Addendum D2

re: **CENTERVILLE-ABINGTON COMMUNITY SCHOOLS**
 Centerville-Abington Elementary School – Window Replacement
 473005.00

issue date: **January 16, 2023**

3 Clerestory Sill Demolition Detail
1 1/2" = 1'-0"

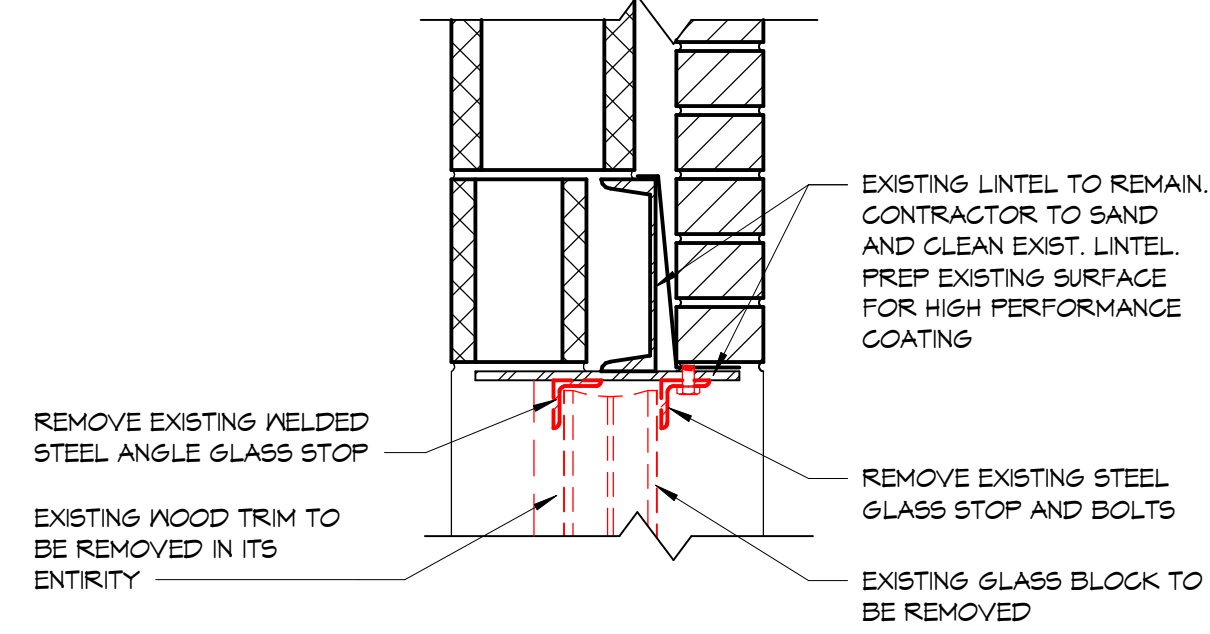
ITEM	LOCATION	DESCRIPTION
A2.04	DRAWING A2.1 (Drawing Reissued)	<u>ADD:</u> Two (2) clerestory windows have been added to the scope of the project. Location of existing clerestory windows have been located on reissued Sheet A2.1. Detail 3-A2.1 has been added to clarify scope of demolition for clerestory windows.
A2.05	DRAWING A4.31 (Drawing Reissued)	<u>ADD:</u> Elevation EX/K has been added to Sheet A4.31 as details 13-A4.31 and 14-A4.31 for new window installation at new condition.
